Review and Recommendations:
WESTCAPS/U.S. Bureau of Reclamation Replication
of the Arizona Department of Water Resources
Current Trends Alternative Simulation

Prepared for:
U.S. Bureau of Reclamation
Phoenix Office

Prepared by:
Peter A. Mock & Associates, Inc.

Subject: Transmittal of Review Report – BOR Replication of Current Trends
Alternative for WESTCAPS

Figure A-1:
 Water Balance Analysis of MODFLOW Model:
 ADWR - Current Trends - as Run by ADWR

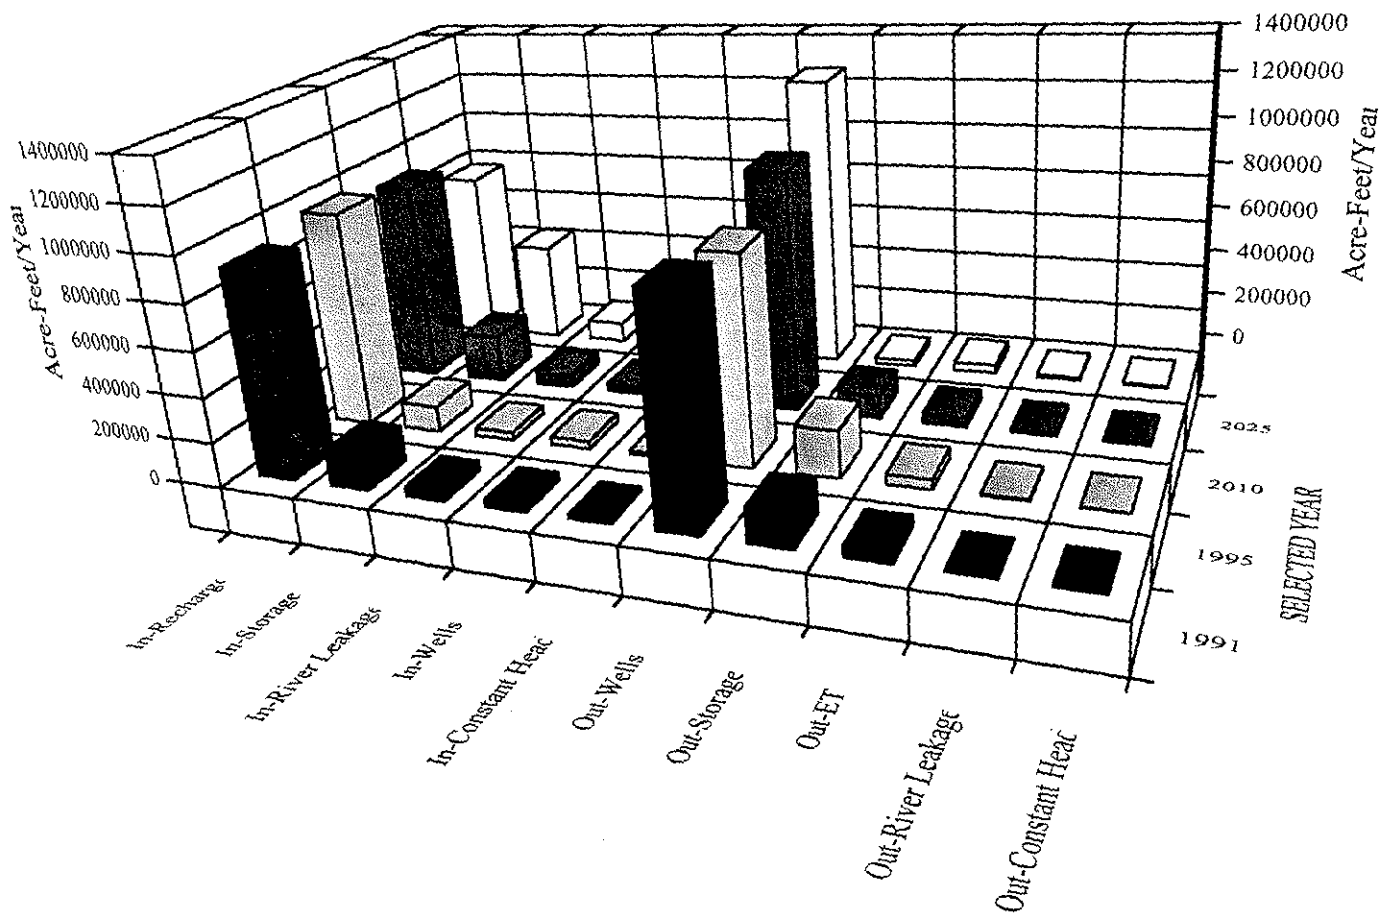
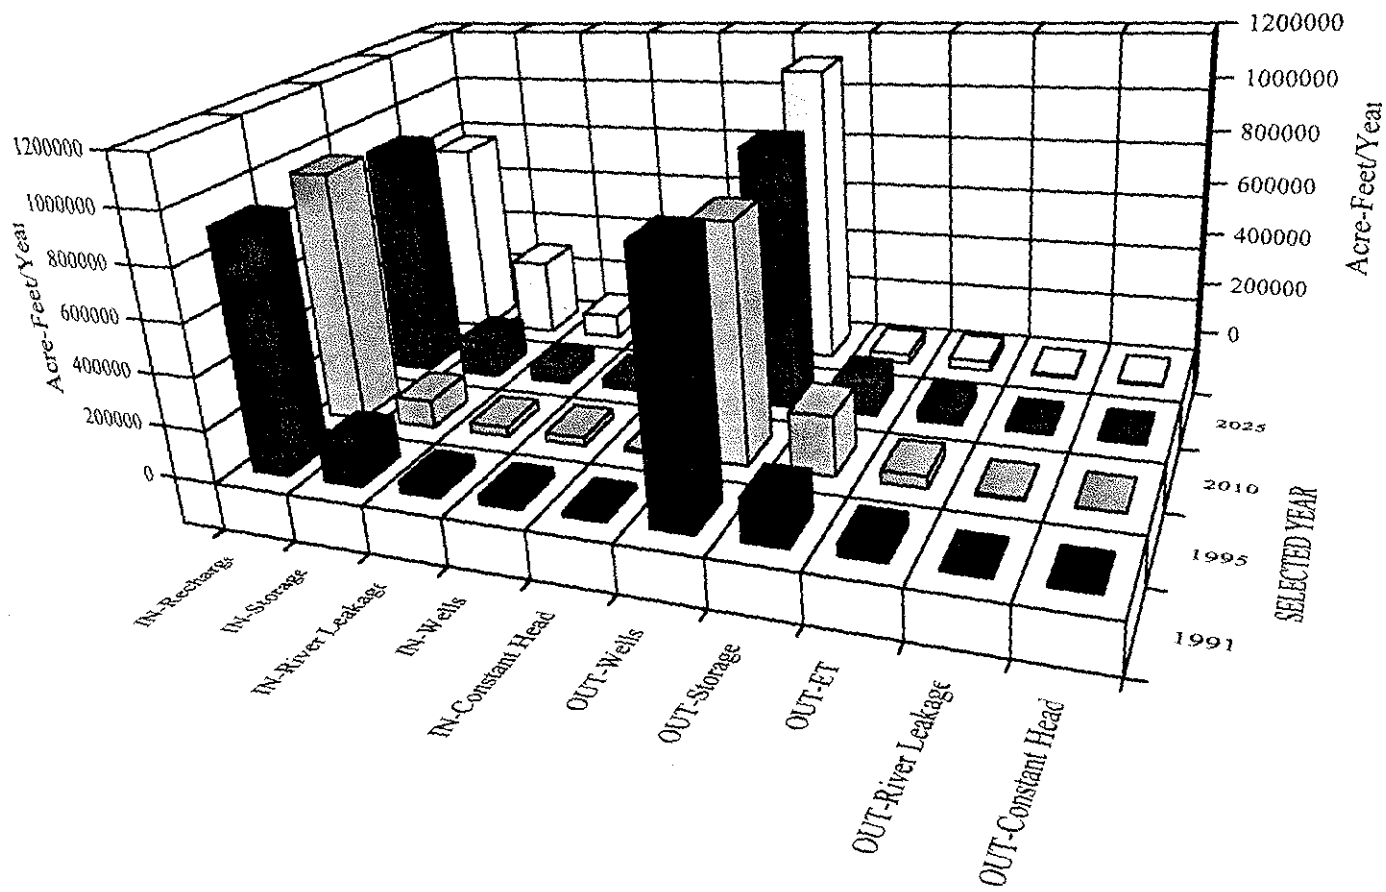
Visual comparison of the mass balance components calculated by the two models is provided for in Figures A-1 and A-2. That the shapes of the graphs are quite similar indicates, as do the values in Tables A-1 and A-2, that the two models are simulating system responses in the Salt River Valley in similar ways.

Figure A-4: Differences of Simulated Upper Alluvial Unit (Layer 1) Water-level Elevations (ADWR minus BOR)

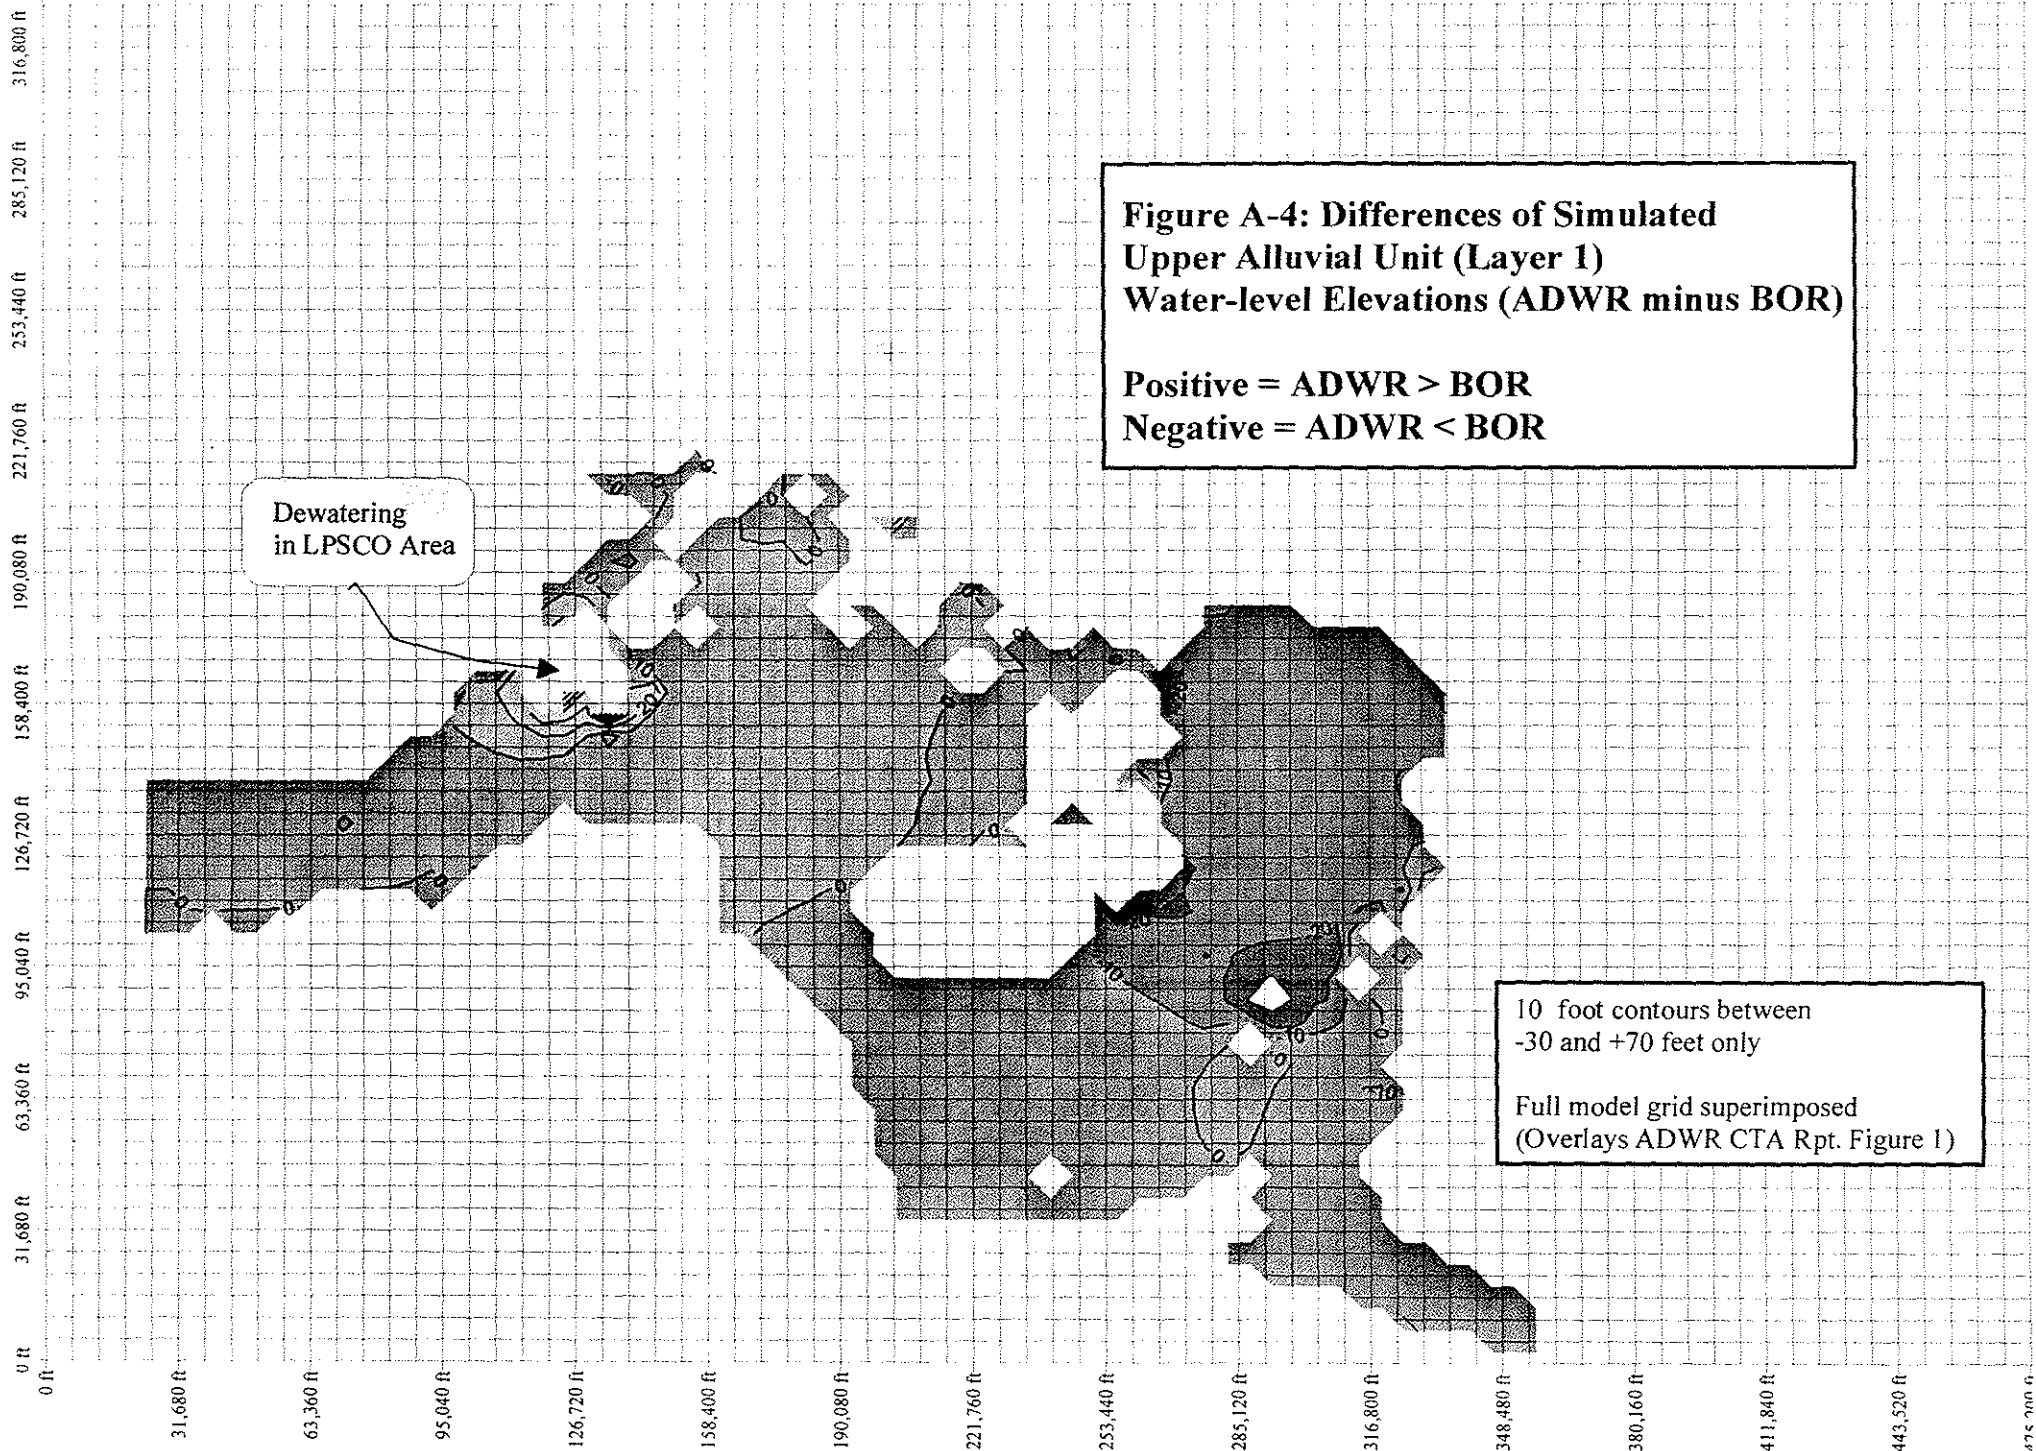
Inspection of Figure A-4 indicates that the differences range in value between 0 and 10 feet over much of the UAU. Exceptions include three small areas of differences greater than 20 feet in ESRV and one area of differences greater than 20 feet in WSRV. The area of differences greater than 20 feet in WSRV is attributed to greater pumping rates applied by BOR in the LPSCO area compared to the ADWR-CTA pumping rates.

Figure A-5: Differences of Simulated Middle Alluvial Unit (Layer 2) Water-level Elevations (ADWR minus BOR)

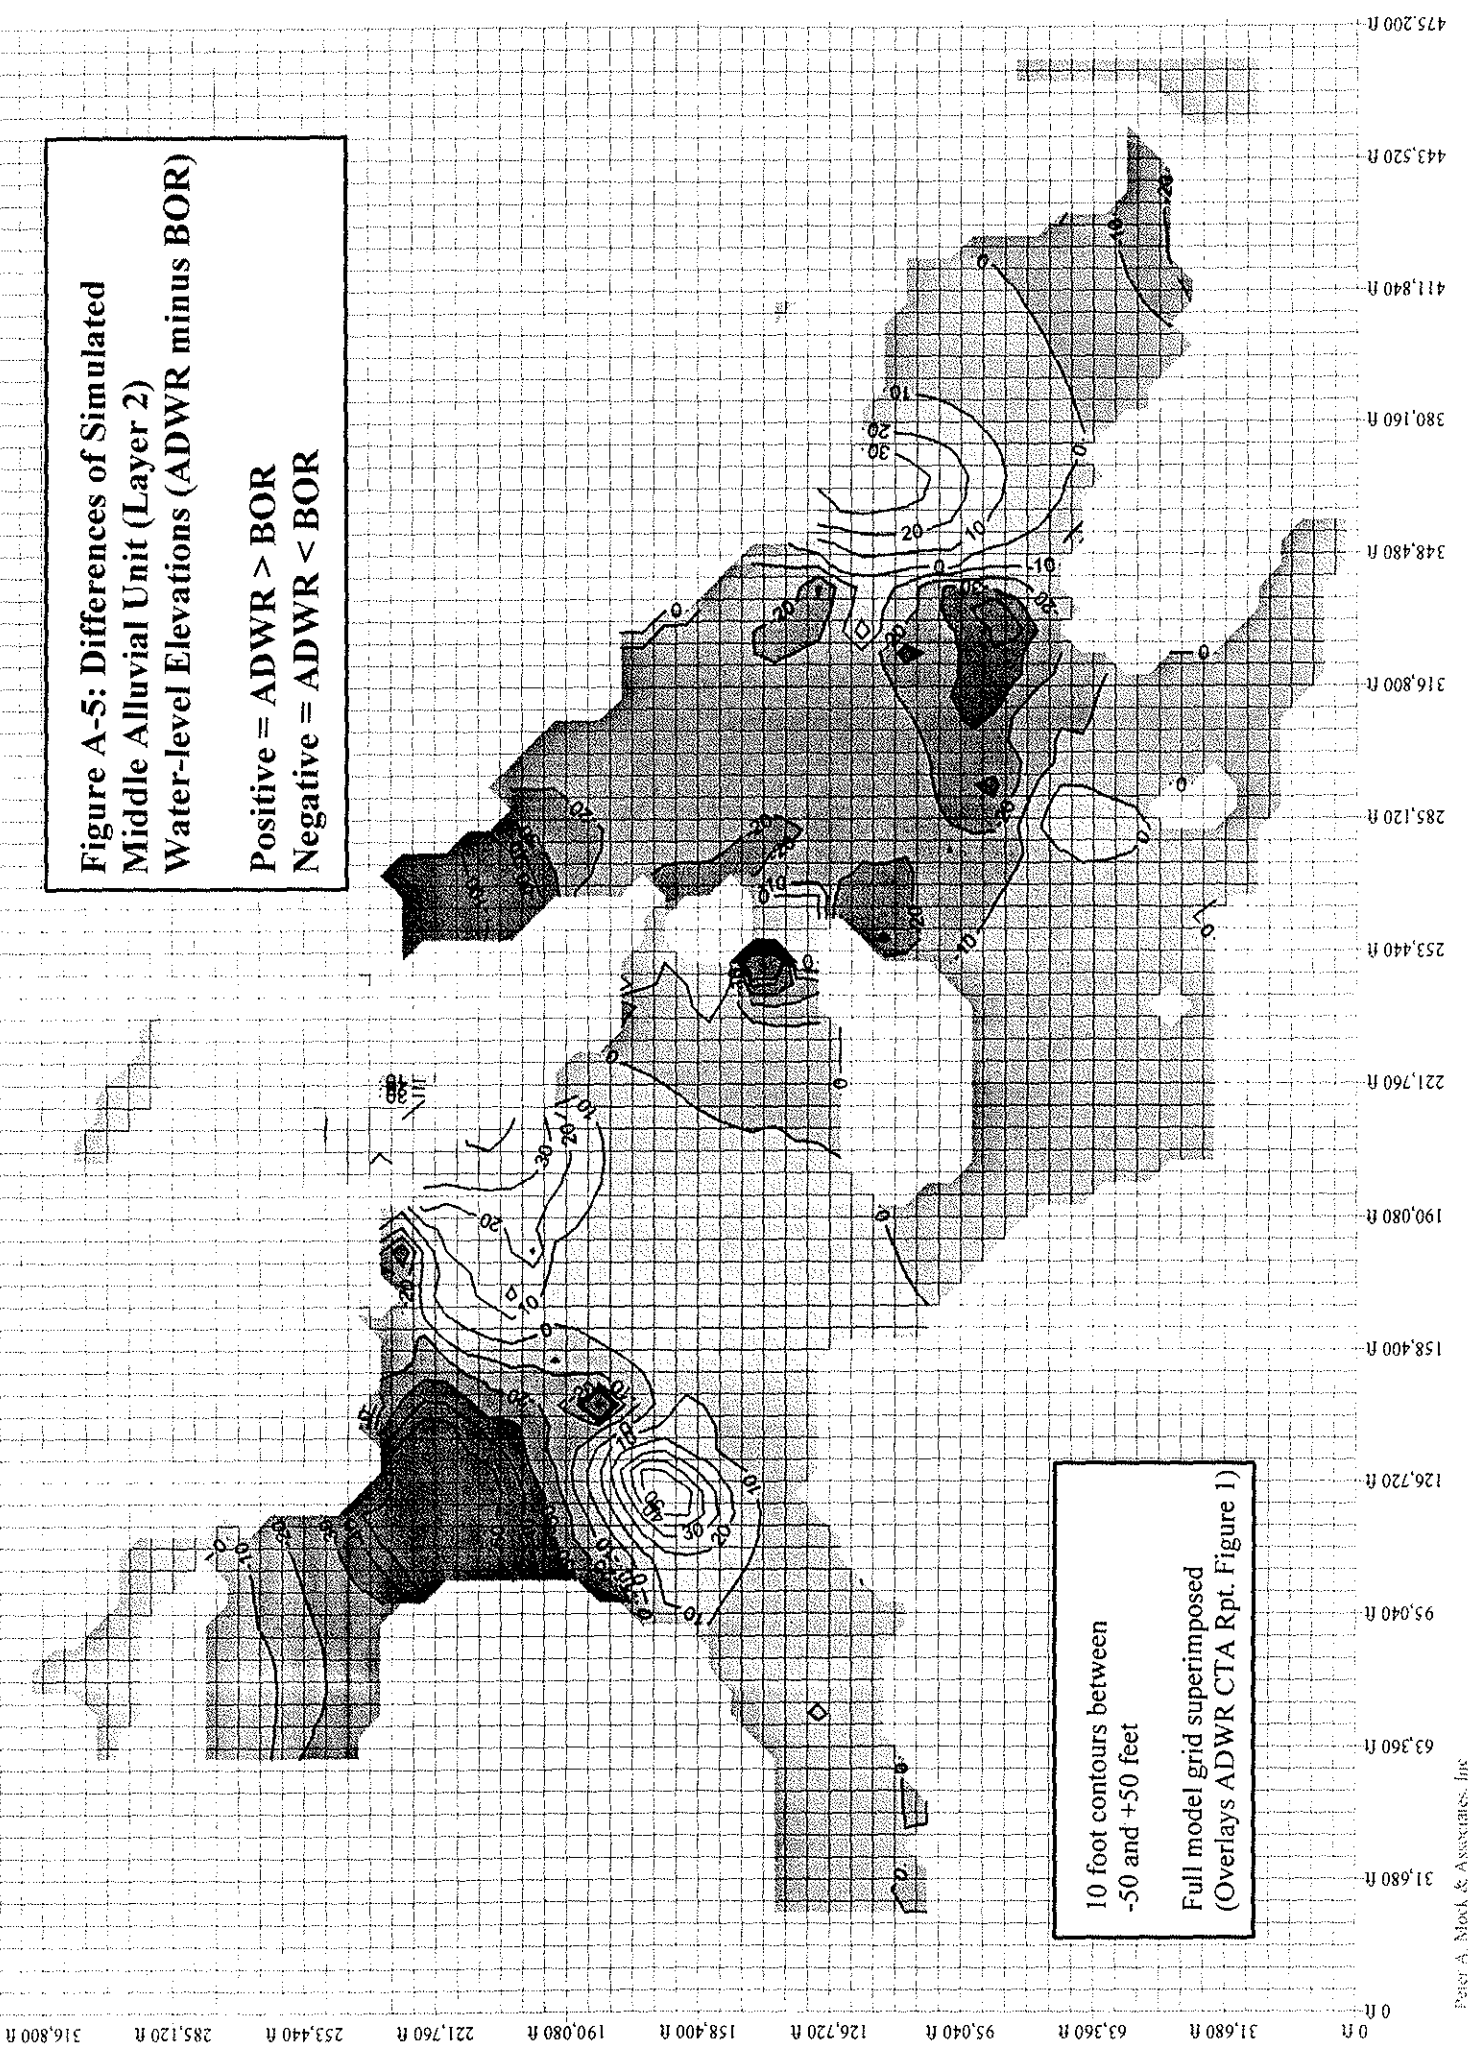
Inspection of Figure A-5 indicates that the differences range in value between 0 and 20 feet over much of the MAU. Exceptions include seven local areas of differences greater than 20 feet in ESRV, six local areas of differences greater than 20 feet in WSRV, and one area of differences greater than 20 feet where flow from ESRV joins the WSRV. Less pumping by BOR than ADWR results in the area of negative differences in a large area of the northwestern WSRV. An adjacent area of positive differences greater than 20 feet in WSRV is attributed to greater pumping rates applied by BOR in the LPSCO area compared to the ADWR-CTA pumping rates.
